APPLICATION FOR PERMIT TO DRILL OR REENTER

Operator Certification Statement
Pintail 23 Federal Com No. 9
Cimarex Energy Co. of Colorado
Unit M, Section 23
T25S-R26E, Eddy County, NM

PECOS DISTRICT
CONDITIONS OF APPROVAL

OPERATOR'S NAME:	Cimarex Energy Co of Colorado
LEASE NO.:	NM94076
WELL NAME & NO.:	9 Pintail 23 Fed Com
SURFACE HOLE FOOTAGE:	250' FS & 650' FWL
BOTTOM HOLE FOOTAGE	330' FNL & 350' FWL
LOCATION:	Section 23, T.25 S., R.26 E., NMPM
COUNTY:	Eddy County, New Mexico

Exhibit E-1 – Choke Manifold Diagram
Pintail 23 Federal Com No. 9
Cimarex Energy Co. of Colorado
23-25S-26E
SHL 250 FSL & 650 FWL
BHL 330 FNL & 650 FWL
Eddy County, NM

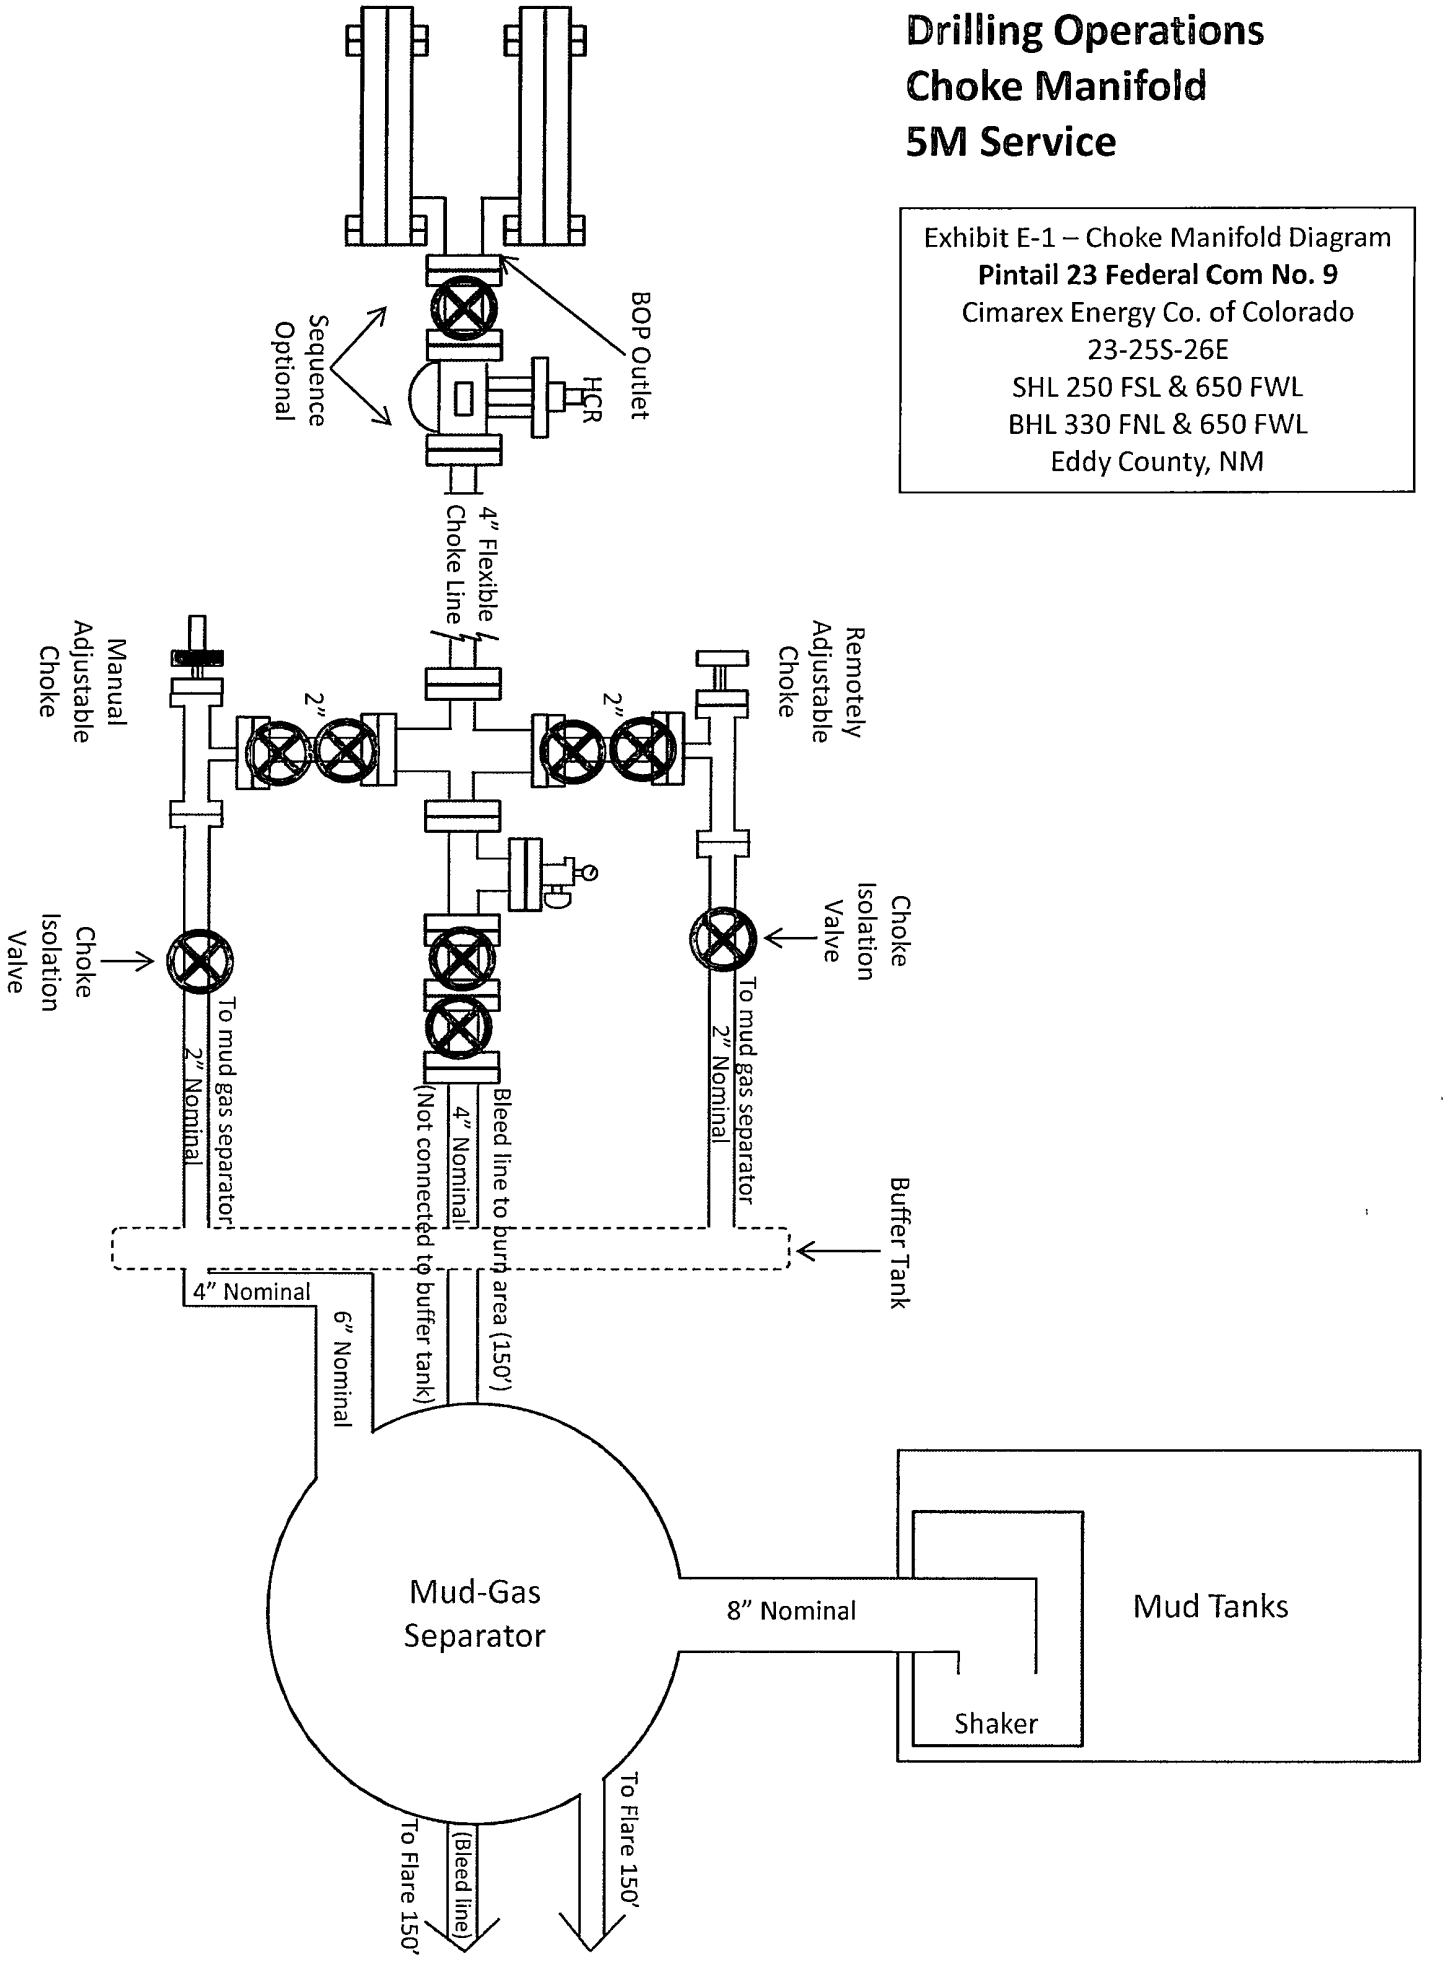
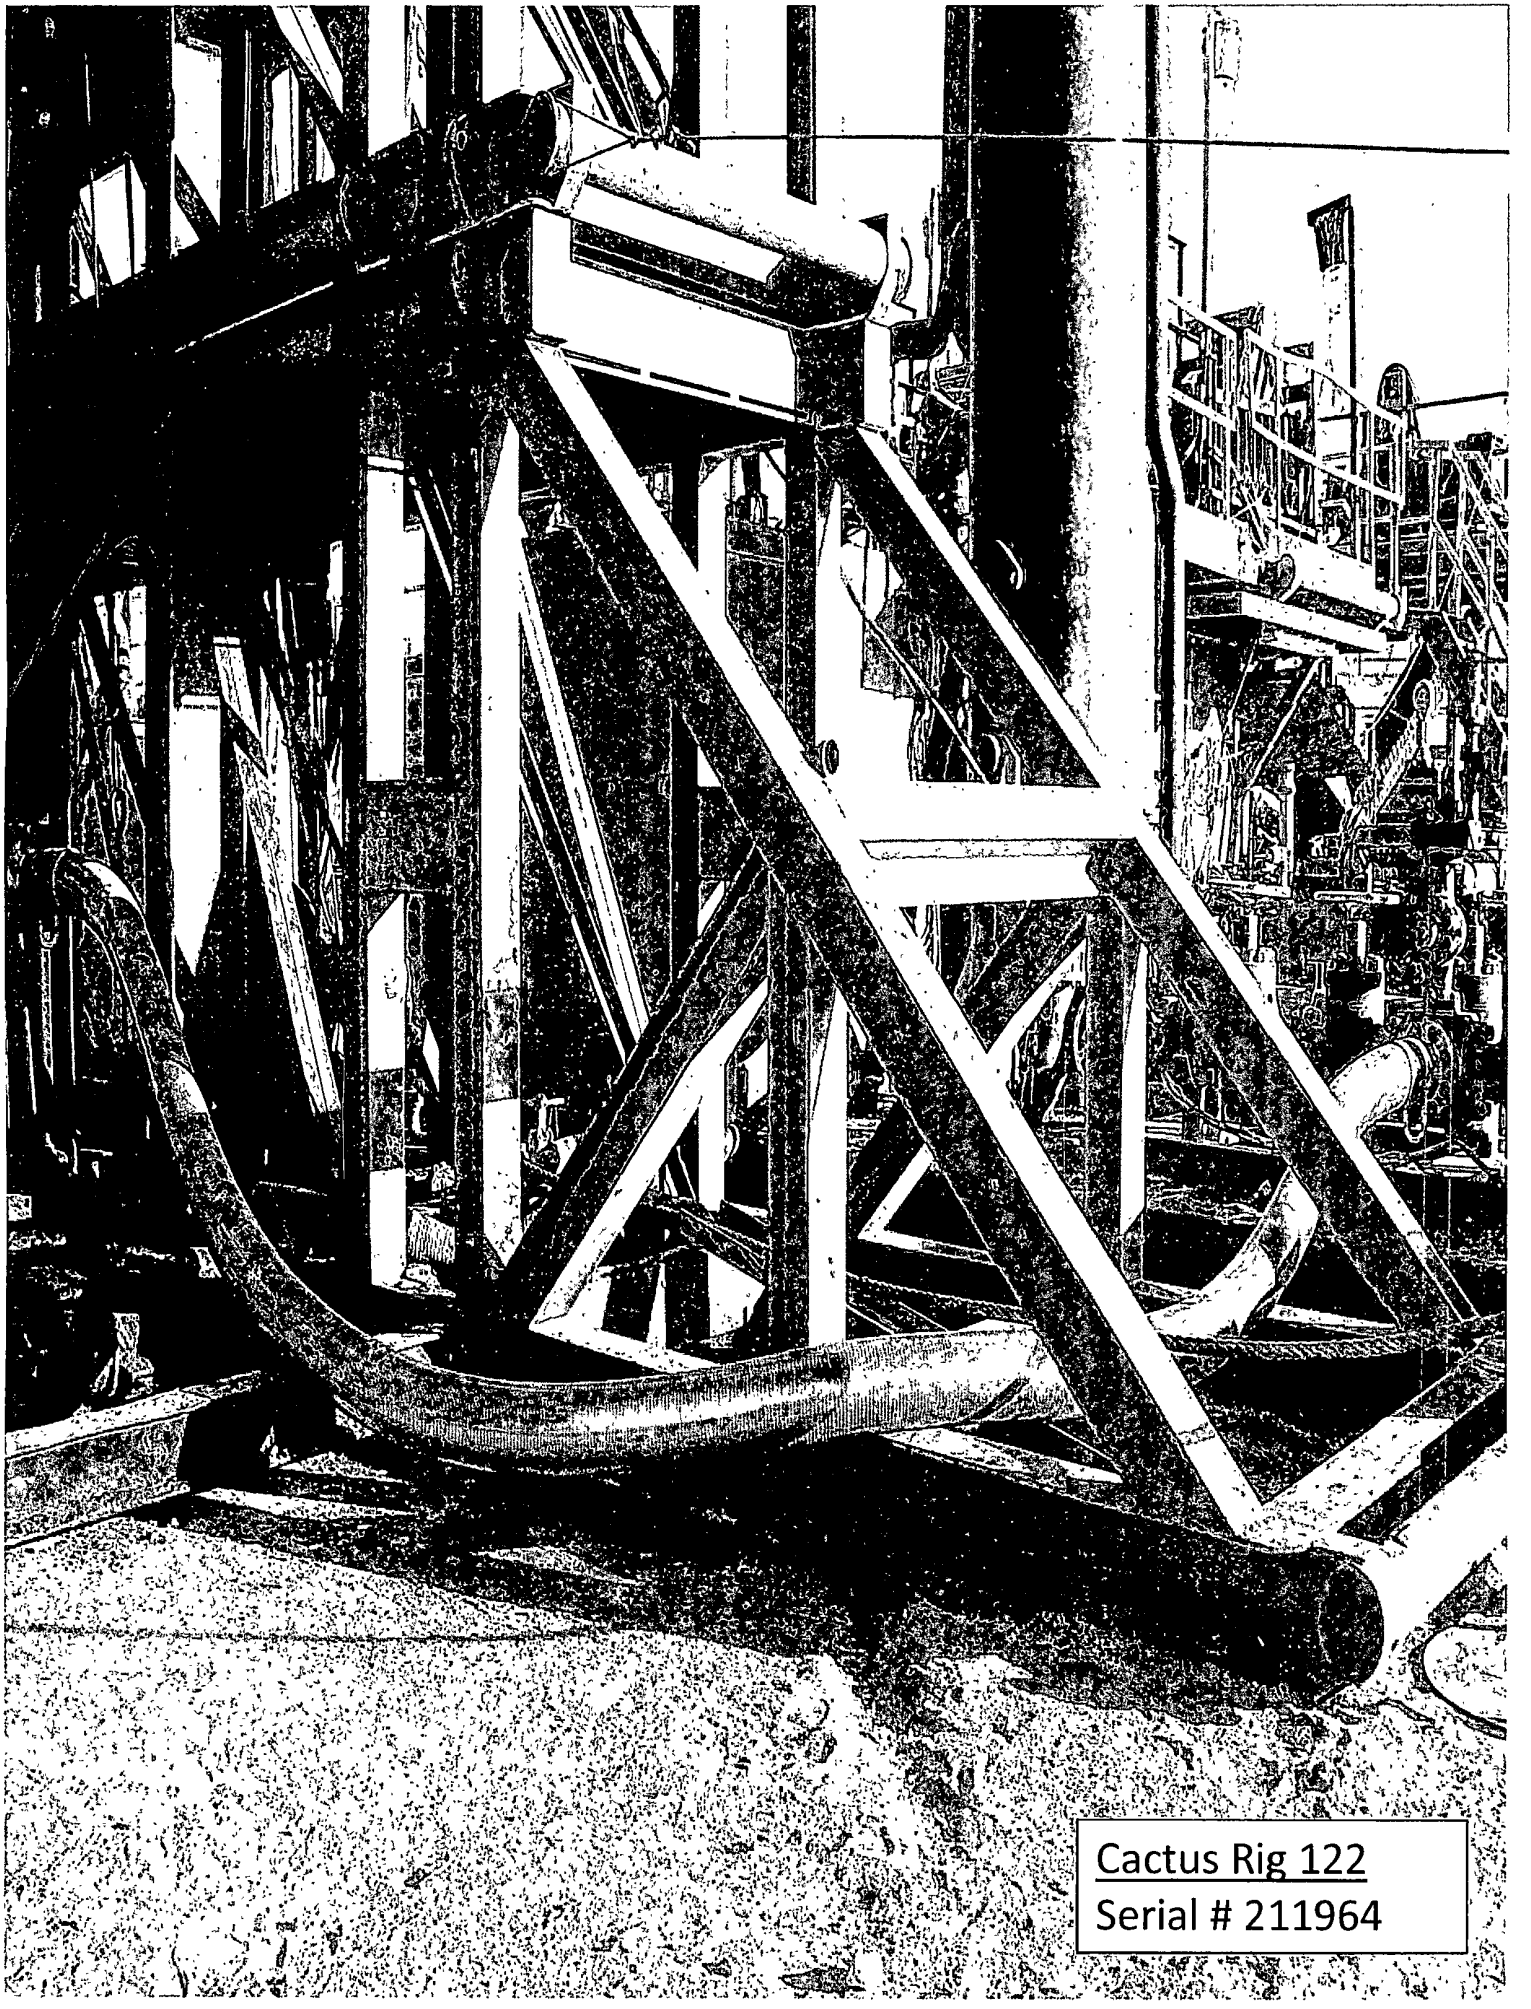
Cimarex Energy Co. of Colorado (operator) requests a variance if Cactus 122 (rig name) is used to drill this well to use a co-flex line between the BOP and choke manifold.
Manufacturer: Midwest Hose & Specialty
Serial Number: 211964 See attached htdrostatic test report
Length: 35' Size: 4-1/16" Ends - flanges/clamps
WP rating: 10,000 psi Anchors required by manufacturer – Yes/No

2. Variance approved to use flex line from BOP to choke manifold. Check condition of flexible line from BOP to choke manifold, replace if exterior is damaged or if line fails test. Line to be as straight as possible with no hard bends and is to be anchored according to Manufacturer's requirements. The flexible hose can be exchanged with a hose of equal size and equal or greater pressure rating. **Anchor requirements, specification sheet and hydrostatic pressure test certification matching the hose in service, to be onsite for review**. If the BLM inspector questions the straightness of the hose, a BLM engineer will be contacted and will review in the field or via picture supplied by inspector to determine if changes are required (operator shall expect delays if this occurs).
